## BRADFORD RANGER DISTRICT

## OIL AND GAS INSPECTION REPORT

OGM Case Numbers: 243, 244 and 245 Date of Inspection: December 03, 2007  
 Weather Conditions: Cloudy, 30's F Persons On-Site: None  
 Warrant/Lot Number: Warrants 2752 & 2445 Mineral Owner/Leasee: Duhring Resource Company  
 Lots 7, 9,  
 Project: To be determined Inspector: Gomola  
 Discussed Operation With: Only FS employees to date  
 Equipment On-Site: None  
 Activity On-Site: Proposed roads and wells were flagged/marked, construction had been begun  
 on part of the package

Pictures 8 and  
9 are the  
culvert  
sediment pond.

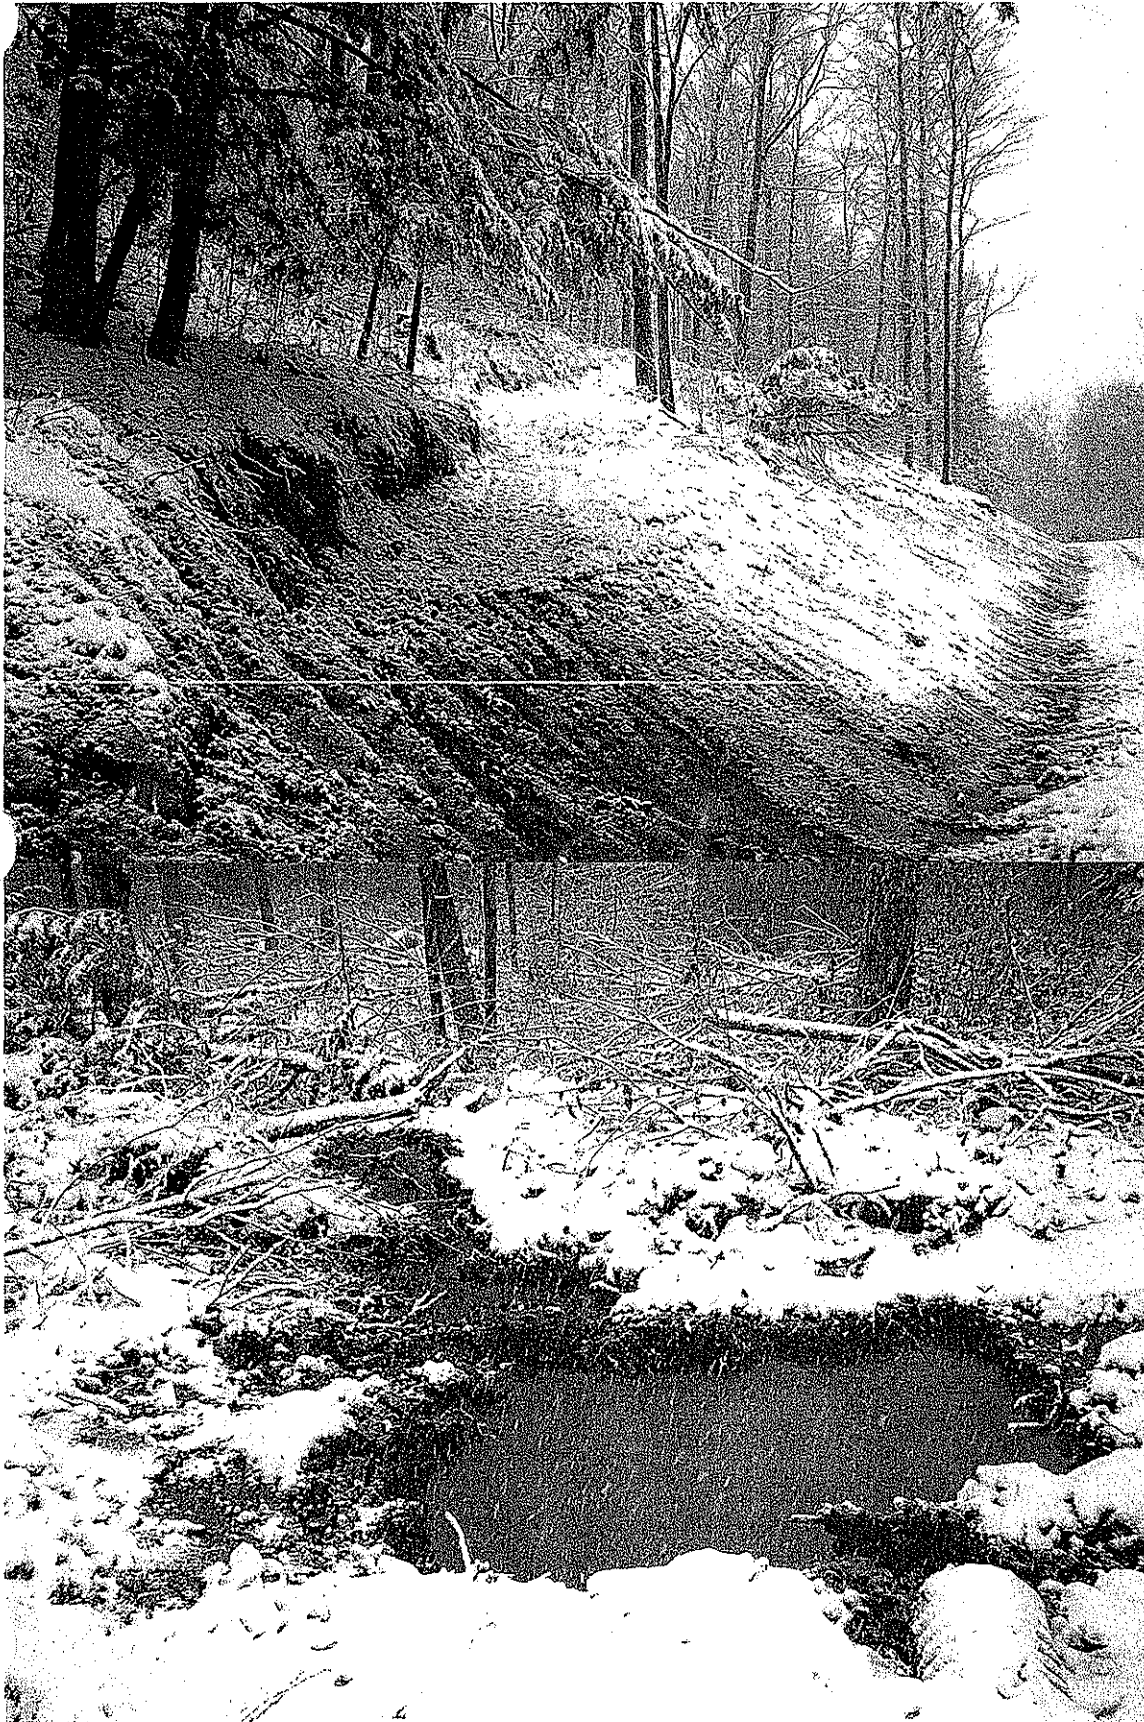
- Access road to wells 21 and 22 has had timber removed and is under construction. There is a poorly placed culvert before the fork in the road leading to well 14, 21, and 22. No E&S controls in place at culvert location just a sediment pond made of on site materials. (see pictures for Lot7-culvert in folder)
